# LRD Forest Road, Forrest Great, Swords, Co. Dublin

Sun on Ground Assessment  
Applicant: Golden Port Homes Limited

3D Design Bureau (3DDB) were commissioned to carry out an updated Sun on Ground (SOG) assessment for the large-scale residential development (LRD) at Forest Road, Forrest Great, Swords, Co. Dublin.

This assessment was undertaken in response, to a request for further information (RFI) issued under application register reference LRD0057/S3E. Specifically, the Planning Authority noted:

Figure 1.1: Revised spaces referenced in the RFI.

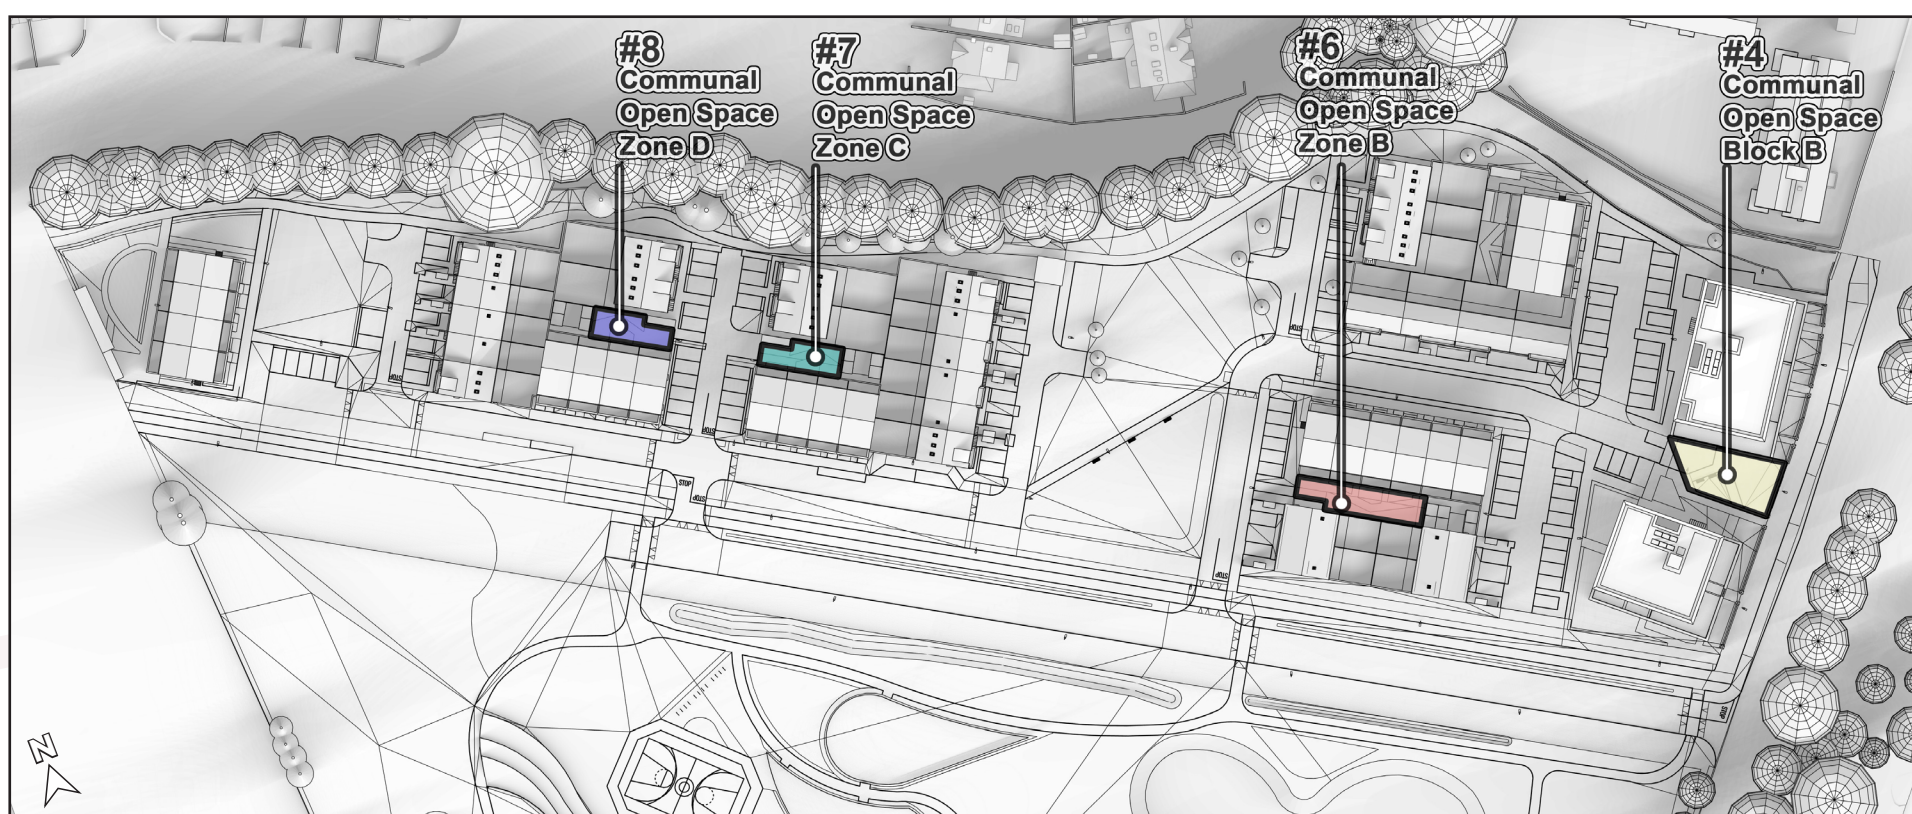
*"7. Based on the 'Daylight and Sunlight Assessment Report' submitted, the communal open spaces serving duplex units in zones B, C, and D would not achieve compliance with BRE Guidelines in respect of sunlight. Furthermore, having regard to the layout and dimensions of these spaces and the spaces in Zone A serving Block B, the Planning Authority is not satisfied that a satisfactory standard of residential amenity would be afforded to future residents. The applicant is requested to submit a revised layout to address this."*

These revised spaces are indicated in Figure 1.1 below.

In response, the design lead, Crawford Architecture, prepared an updated design in consultation with RMDA Landscape Architects to address the concerns raised. 3DDB then updated the analytical model and ran the updated SOG analysis based on the revised drawings and 3D model provided.

Figure 1.2: Indication of the amenity areas that have been analysed.

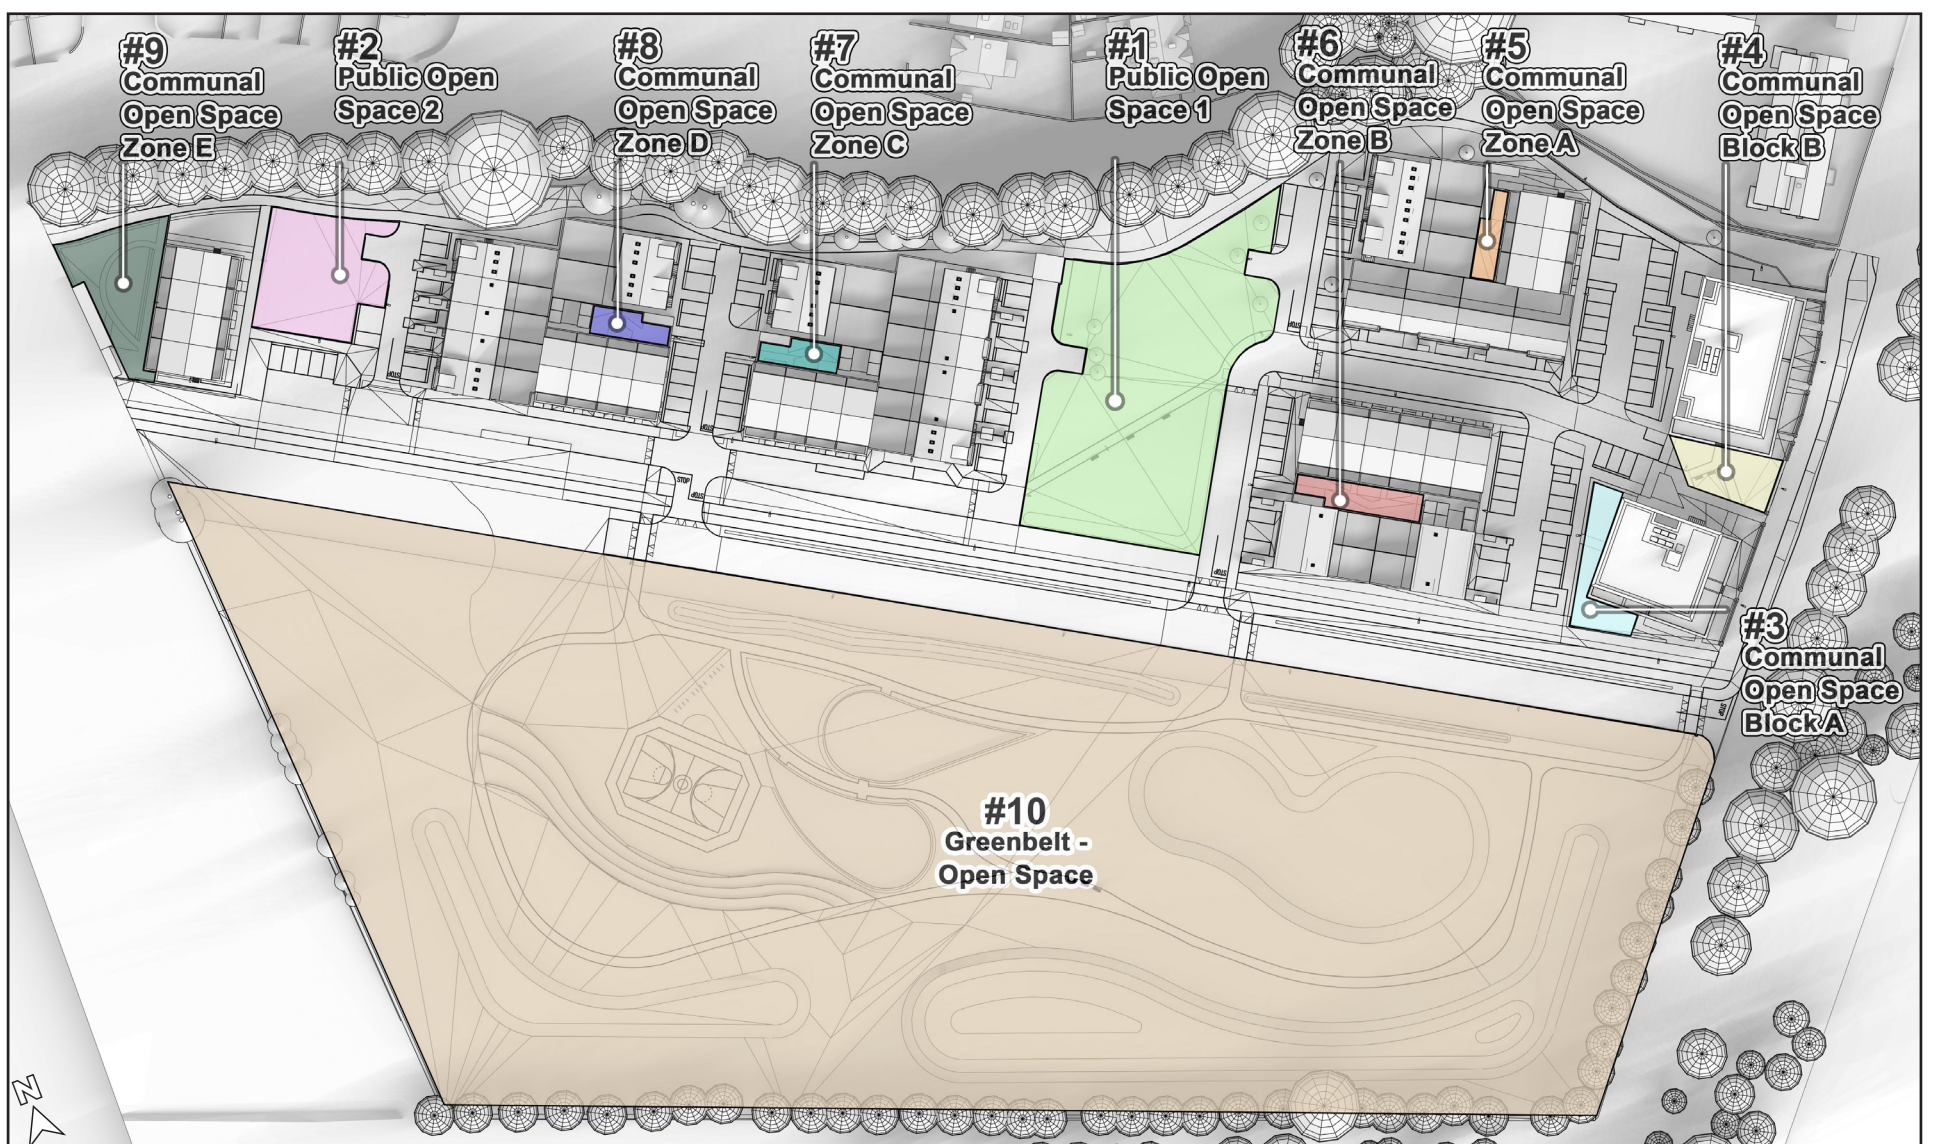
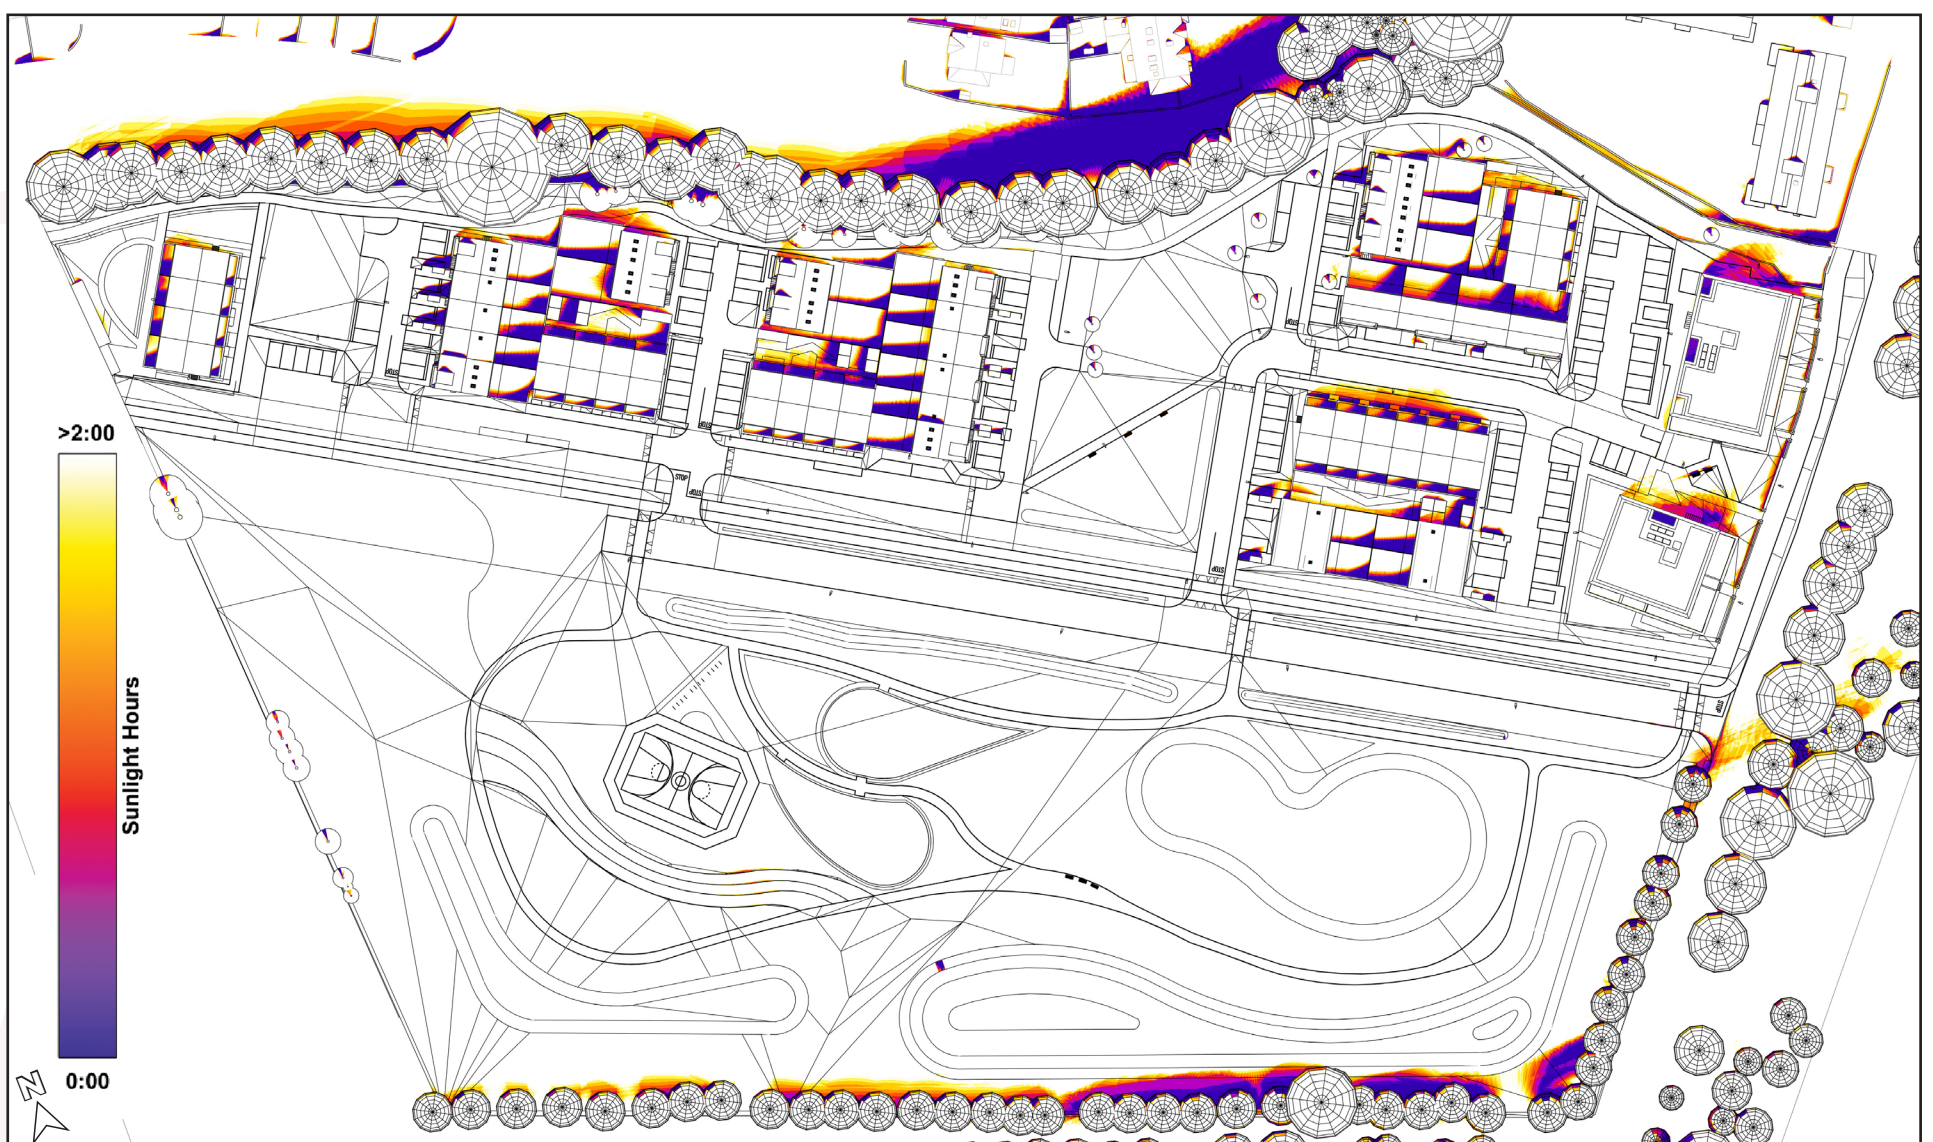
The shortfall continues to arise in communal area #7 (Zone C), which is constrained by its position to the north of duplex units and its narrow layout, both of which limit sunlight penetration. Despite not meeting the criteria this space records an improvement when compared with the previous layout. The area capable of receiving 2 hours of sunlight on March 21st in this space has increased to 37.17%, compared with 16.76% previously.

While the Communal Open Space in Zone C remains below the 50% BRE guideline, the following compensatory design measures and contextual factors have been supplied by the project architect in support of the overall high standard of amenity for future residents of the associated duplex units:

1. The bike parking was moved from the front of the unit to the back to increase security for residents and to make the communal open space deeper, and more usable. The corner where the bike parking is situated is not counted in the communal open space area of 84m<sup>2</sup>.

2. These units benefit a southerly aspect over a large public open space to the south of the site with a playground, sports facilities and walking trail.

3. There is a large public open space (2154m<sup>2</sup>) on the site, 31m away. There is an additional public open space (519m<sup>2</sup>) 71m away. Residents have ample choice of open amenity to use.

4. The upper unit has a south facing balcony at second floor level, which is 0.5m<sup>2</sup> above the minimum area.
5. The ground floor unit has a terrace 0.6m<sup>2</sup> above the minimum requirement.
